RE: U.S. ARMY

FORT TOTTEN

I visually inspected the following boilers in compliance with NYC Local Law 62/91, New York State Sec 204 of NYS Labor Law and The National Fuel Code. The boilers and the boiler rooms were visually inspected to be code compliant and condition evaluated. This inspection did not include any performance testing.

BUILDING 118

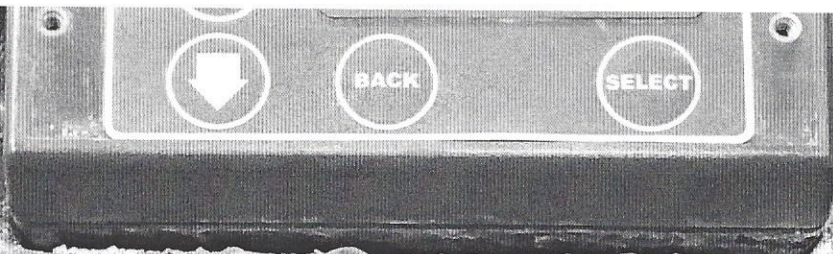
Boiler room has a violation. There is an electrical box that requires to be covered.

Recommend moving "Z" exhaust 6-inch diameter vent down appx. 2 feet down away from the electrical box.
